**Re: Addendum No. 4**  
**City of Canton Water Reclamation Facility**  
**Phosphorus/Total Nitrogen Project Contract No. 26**

Date: January 2, 2014

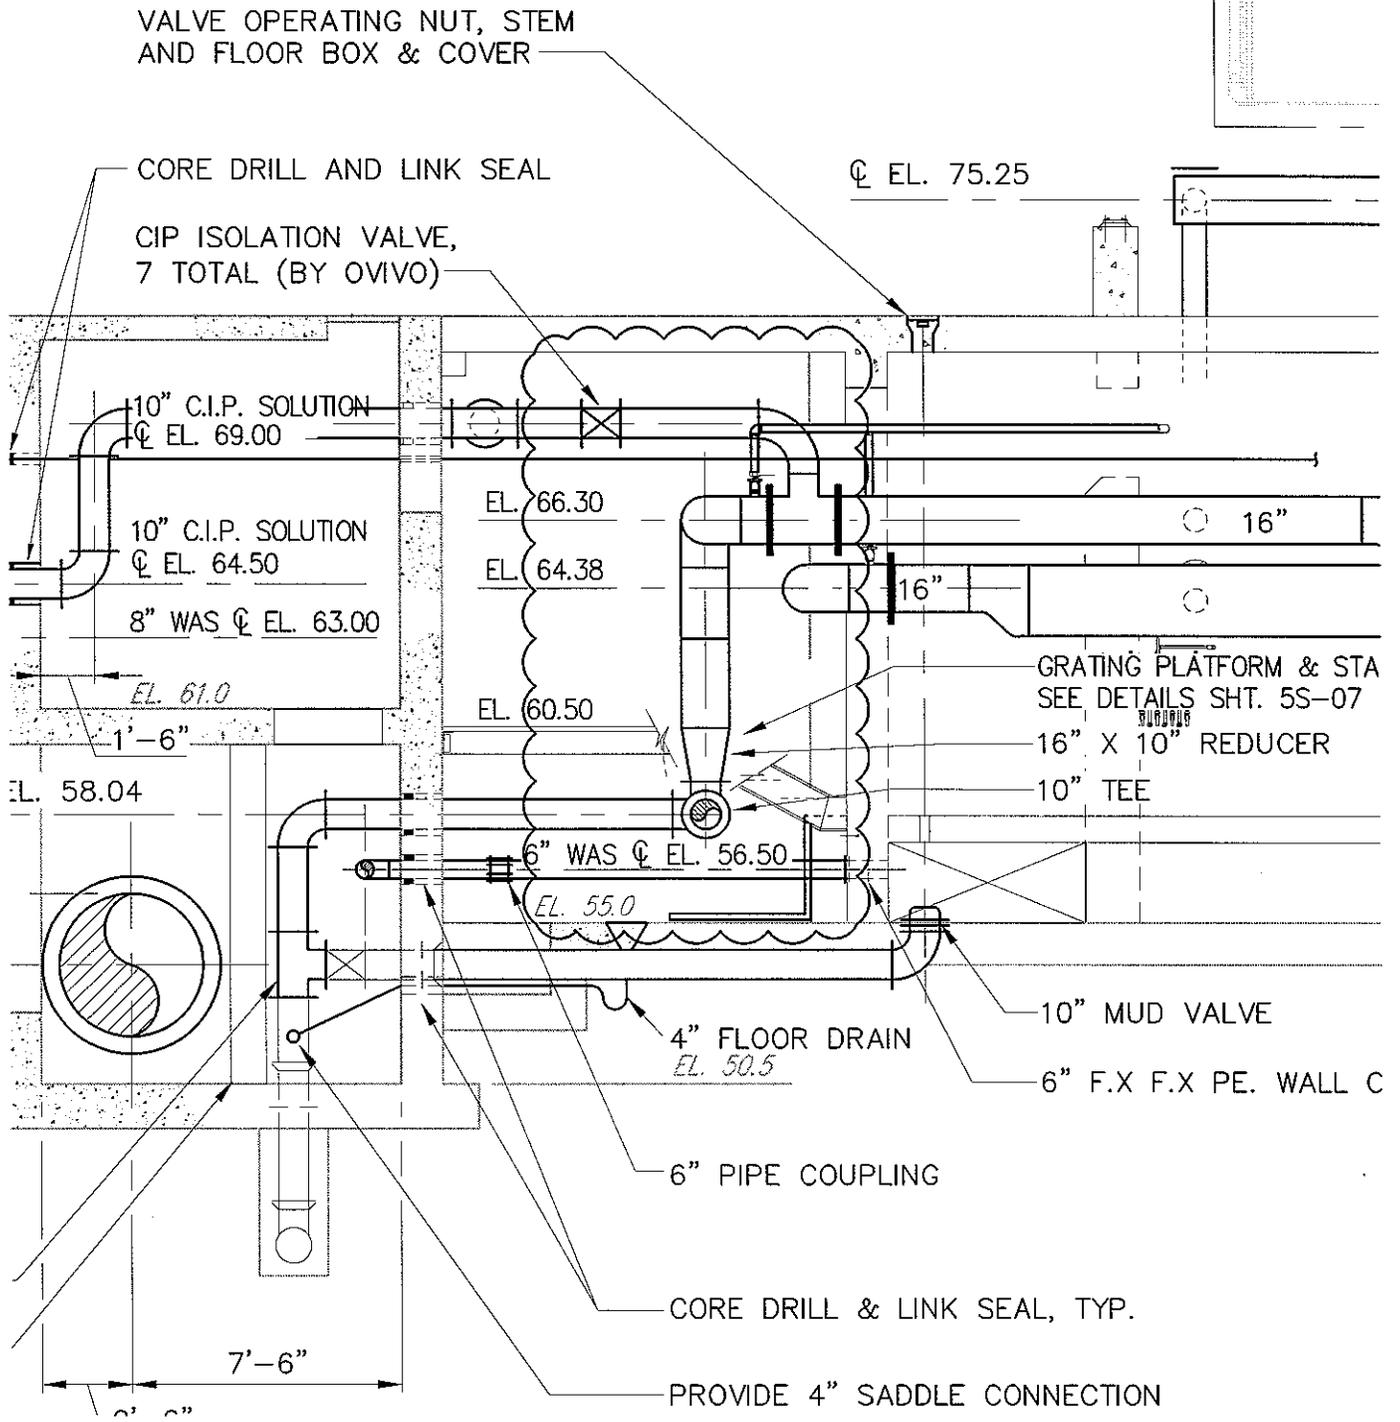
Sheet 139 5P-05 Sketch P-5 **REVISE** Permeate Piping Layout, **ADD** Pump Pier.

REVISED PERMEATE PIPING LAYOUT, ADD PUMP PIERS

NOTE: THIS DRAWING SHALL BE CONSIDERED TO BE PART OF SHEET 140 OF 375 - 5P-06.

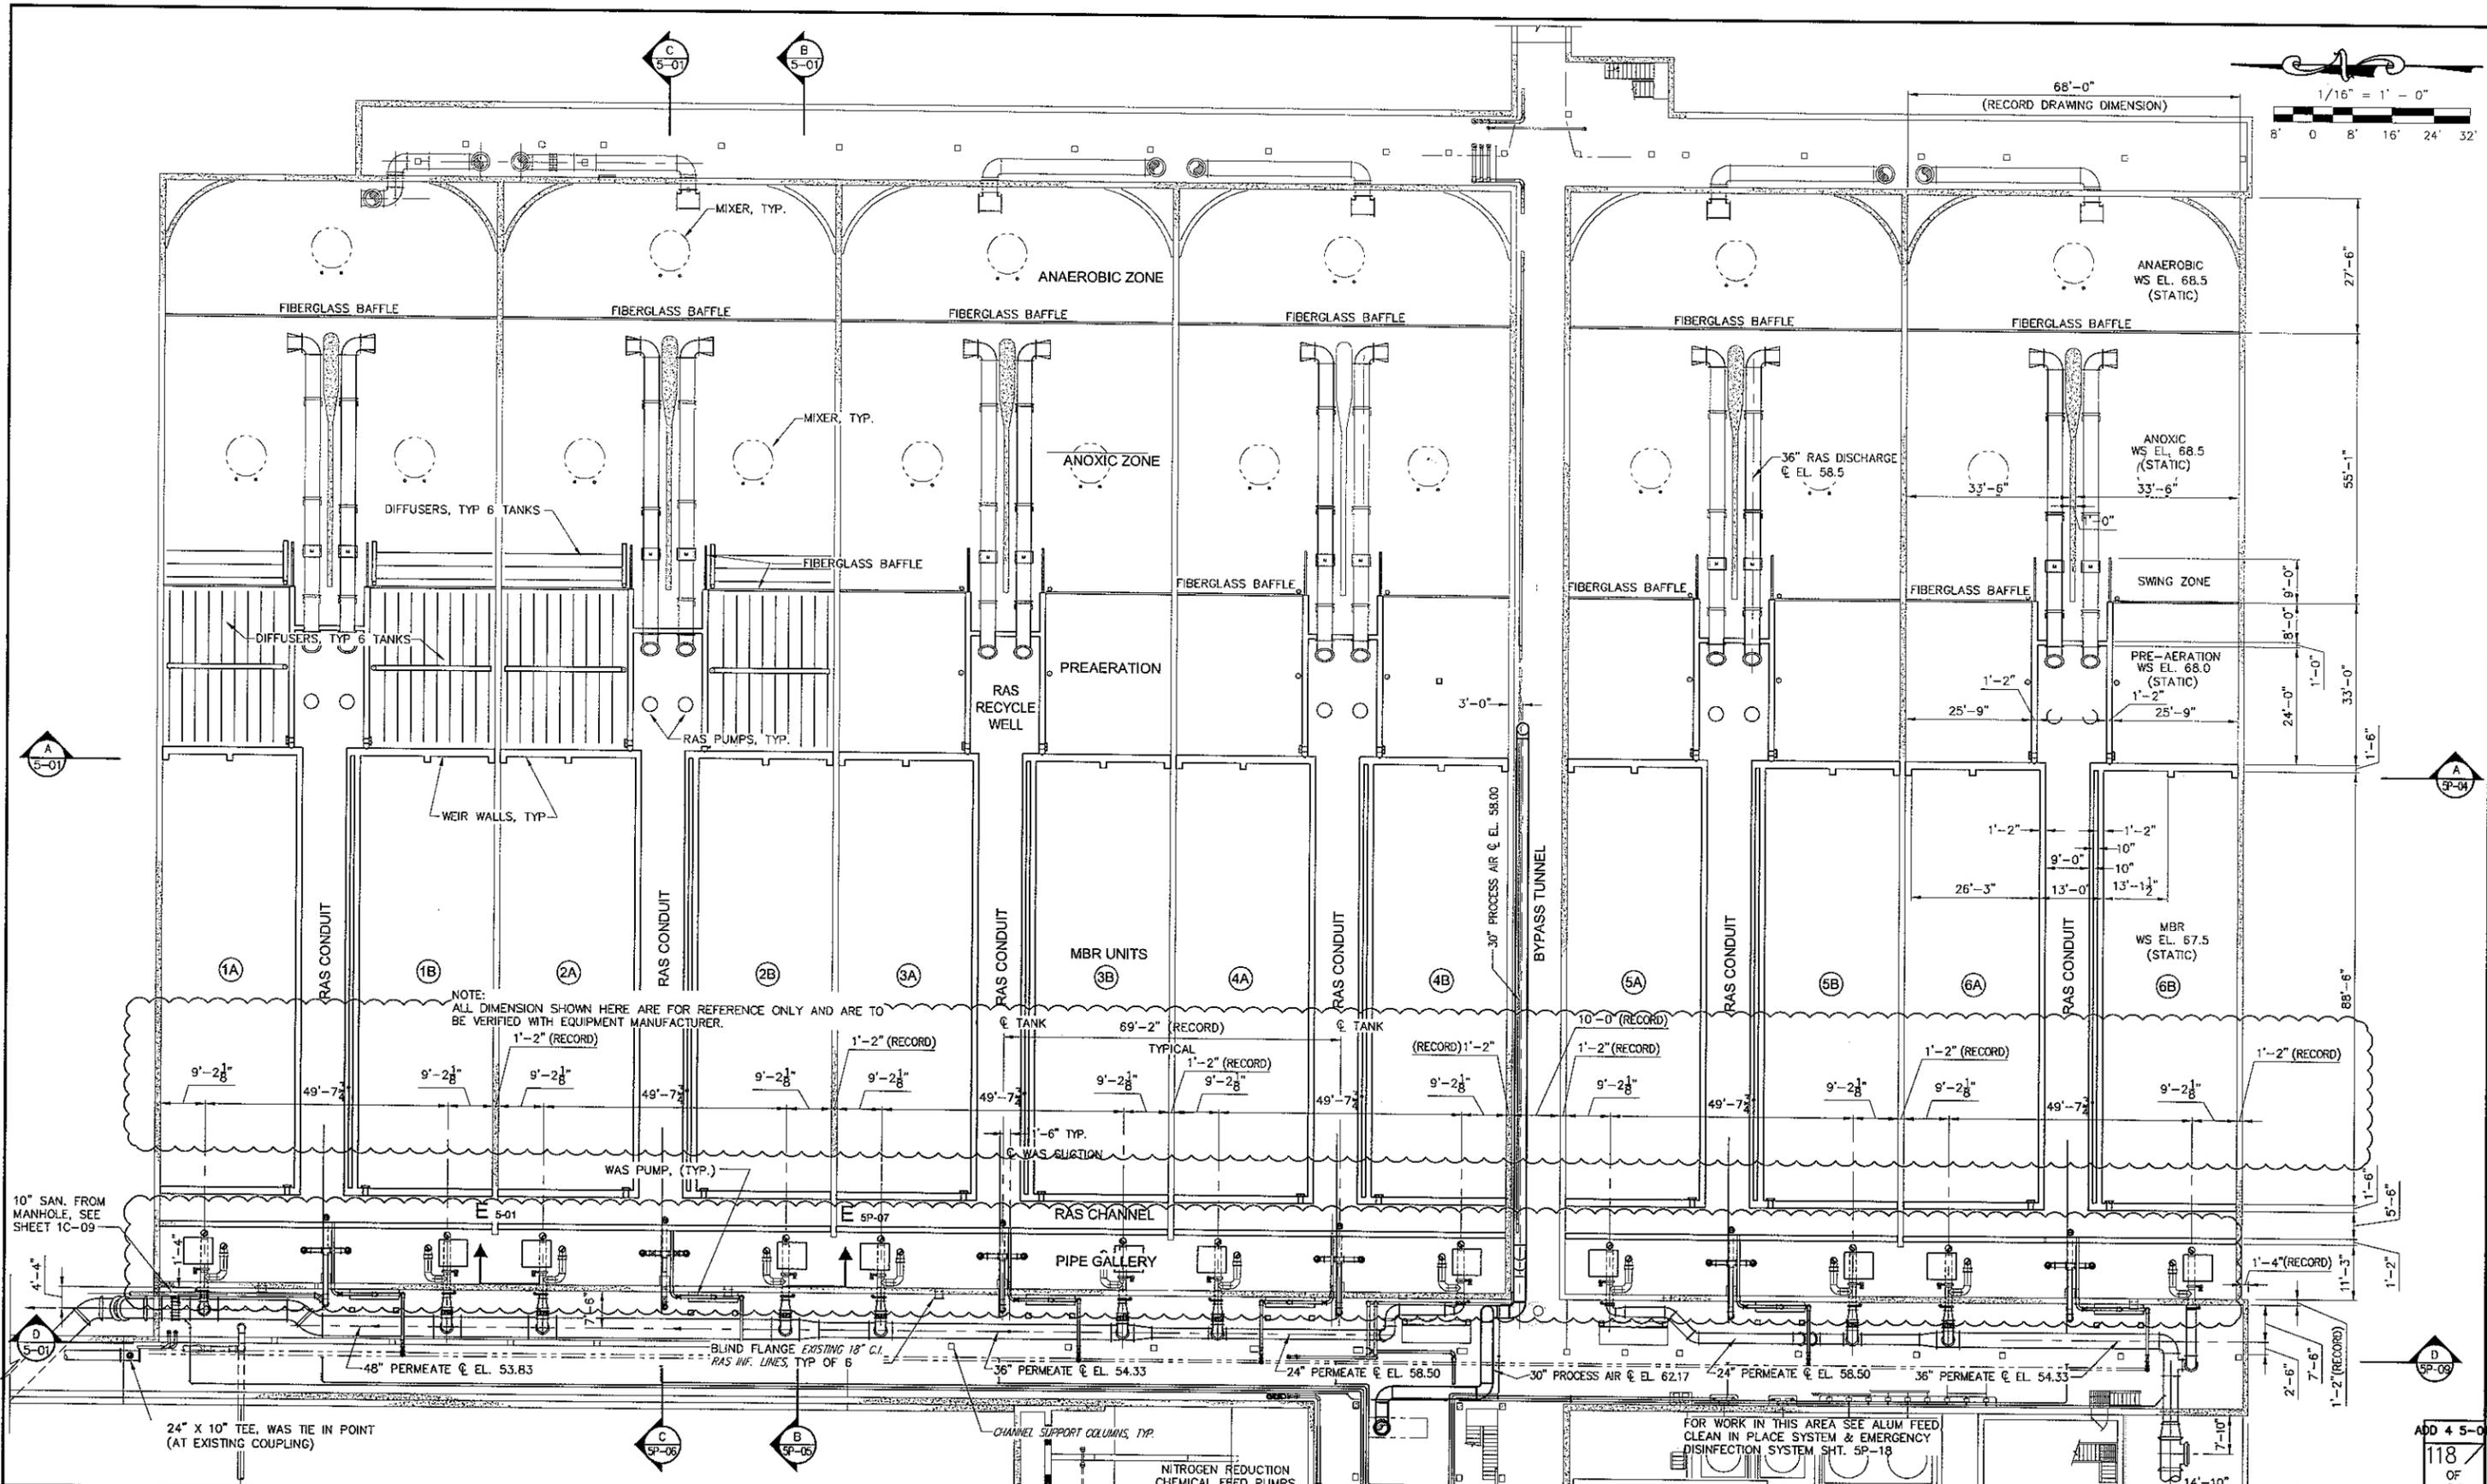
Sheet 140 5P-06 Sketch P-6 **REVISE** Permeate Piping Layout.

REVISED PERMEATE PIPING LAYOUT

ADD 4 5-01  
 118  
 OF  
 375

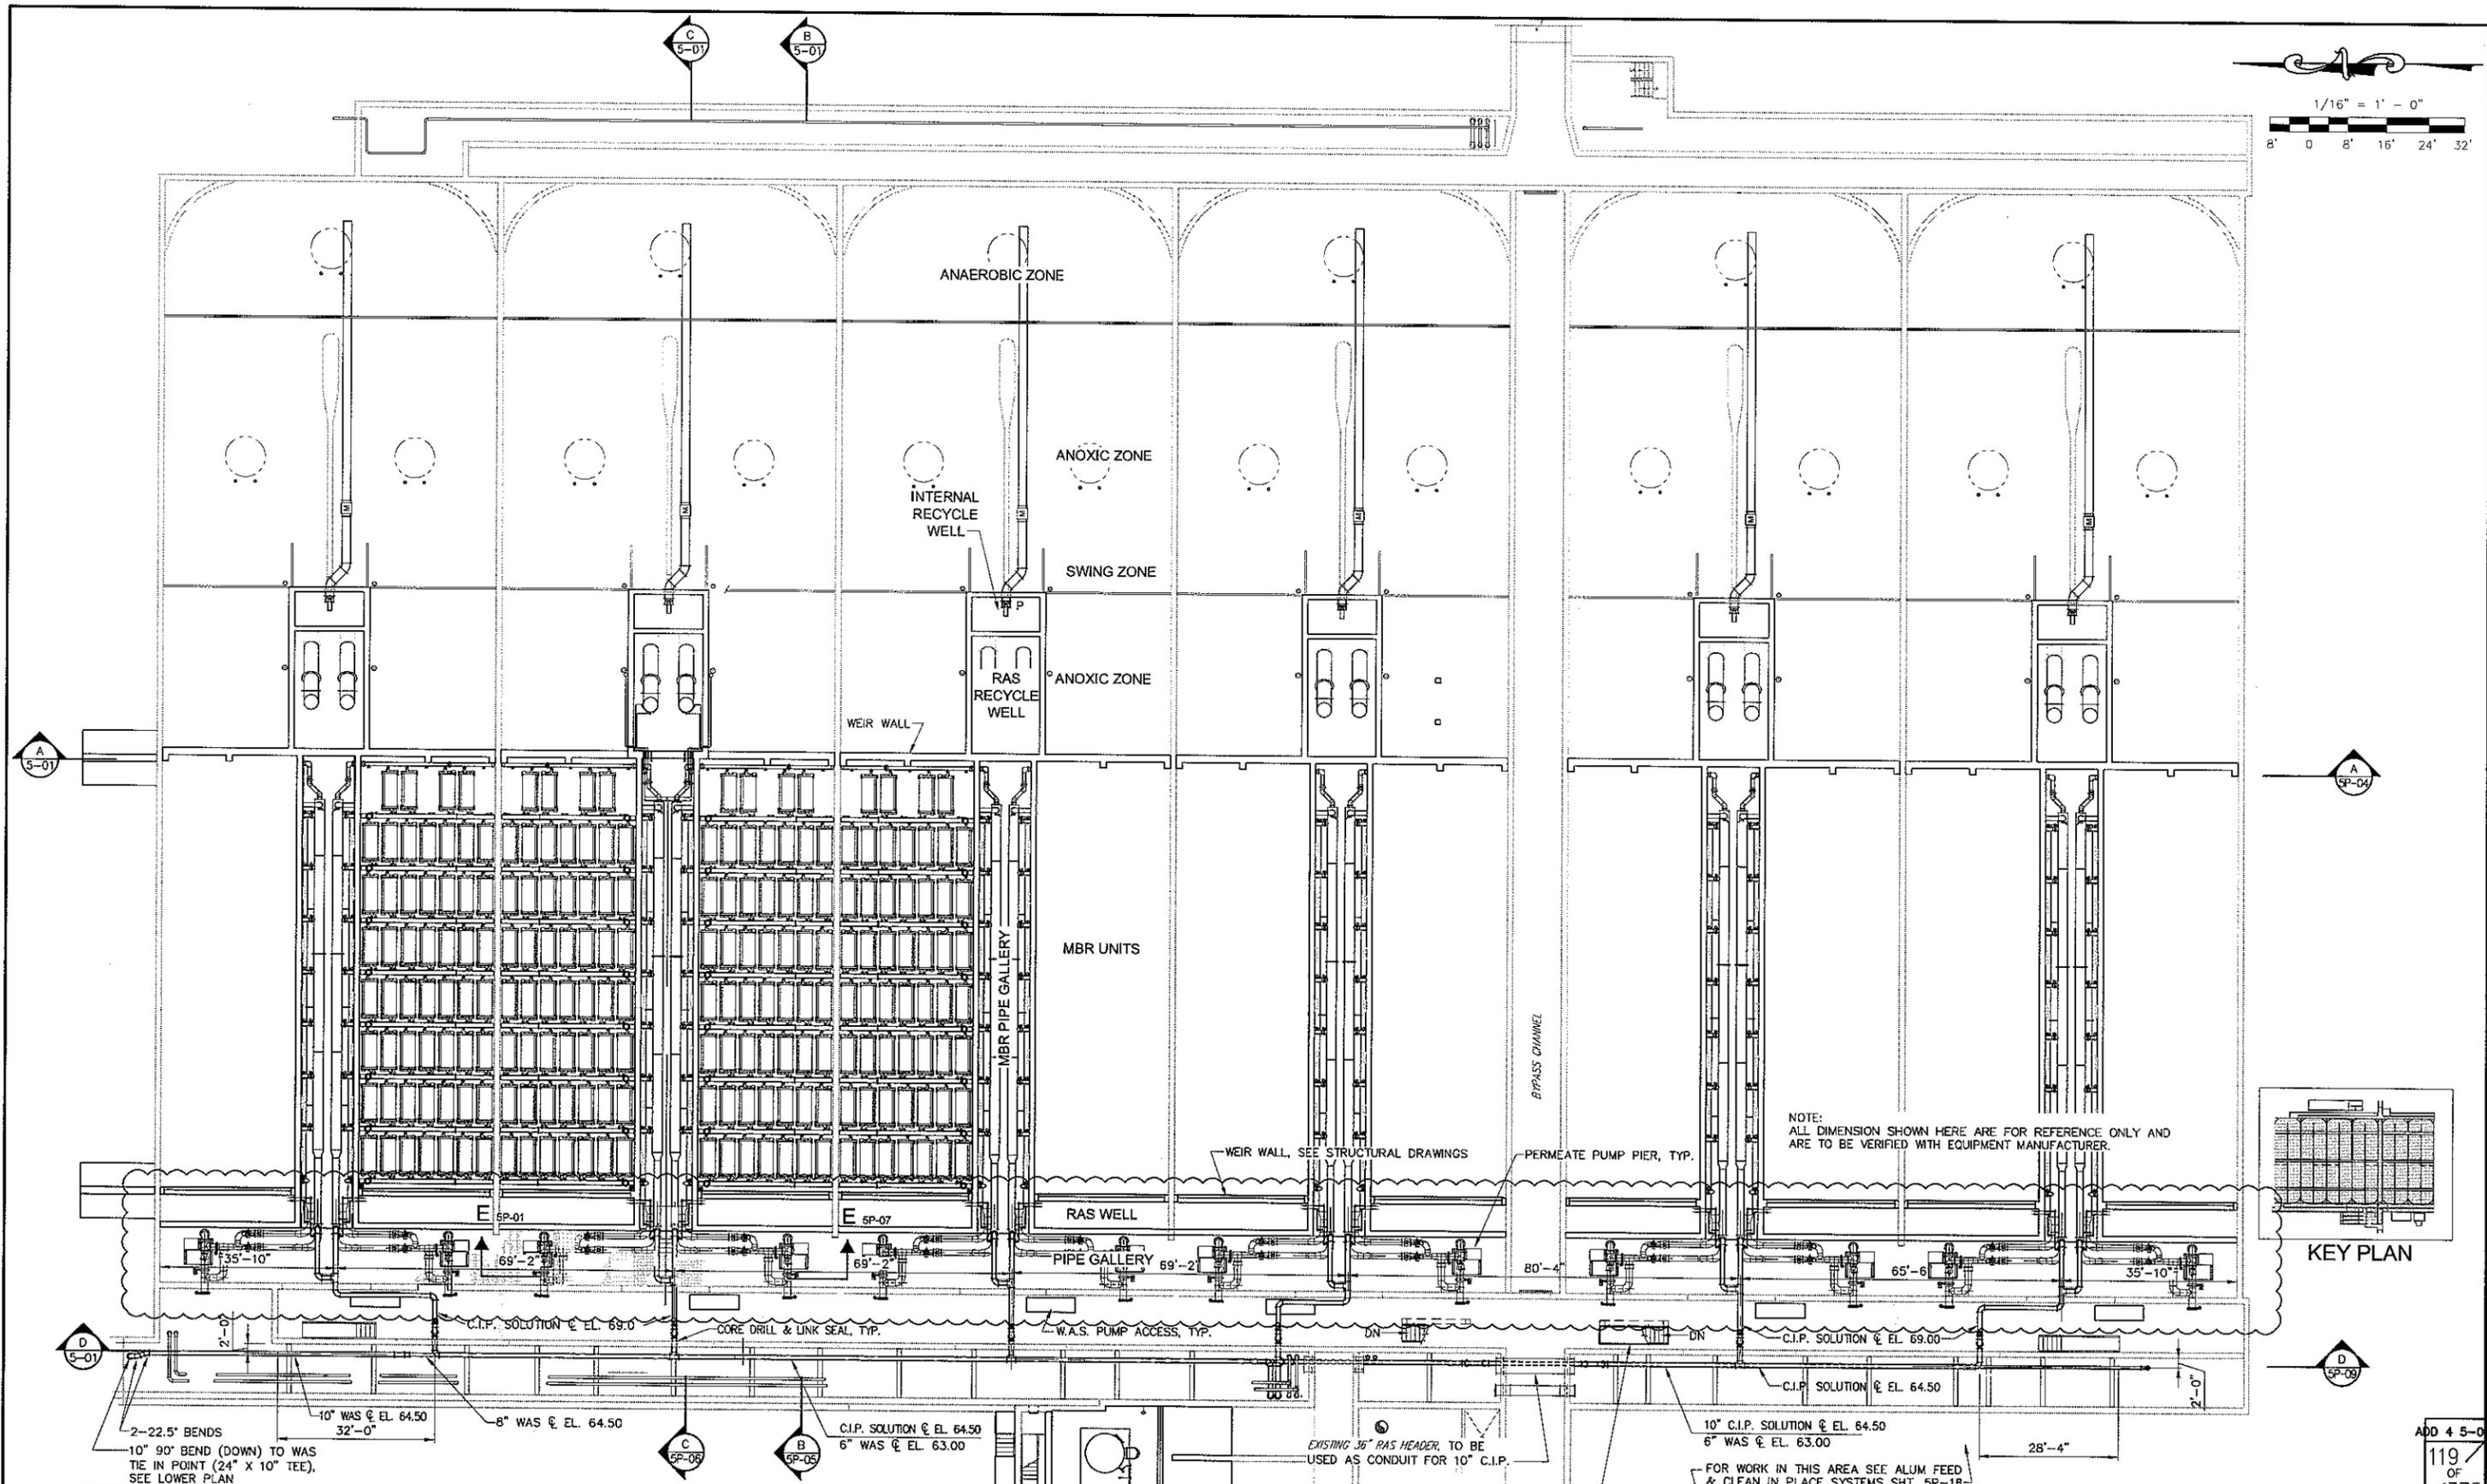
- Sheet 118 5-01 **REVISE** Permeate Piping Layout, **ADD** Pump Piers.  
Sheet 119 5-02 **REVISE** Permeate Piping Layout, **ADD** Pump Piers.  
Sheet 135 5P-01 **REVISE** Permeate Piping Layout, **ADD** Pump Piers.  
Sheet 136 5P-02 **REVISE** Permeate Piping Layout, **ADD** Pump Piers.  
Sheet 141 5P-07 **REVISE** Permeate Piping Layout, **ADD** Pump Piers.  
Sheet 142 5P-08 **REVISE** Permeate Piping Layout, **ADD** Pump Piers.  
Sheet 208 10D-06 **REMOVE** and **REPLACE** Sheet.  
Sheet 209 10D-07 **REMOVE** and **REPLACE** Sheet.  
Sheet 210 10D-08 **REMOVE** and **REPLACE** Sheet.  
Sheet 217 10S-04 **REMOVE** and **REPLACE** Sheet.  
Sheet 218 10S-05 **REMOVE** and **REPLACE** Sheet.

NO.	REVISION DATA	DATE	BY	APP'D
1	REVISED PERMEATE PIPING LAYOUT, ADD PUMP PIERS	12/13	RLM	CWJ
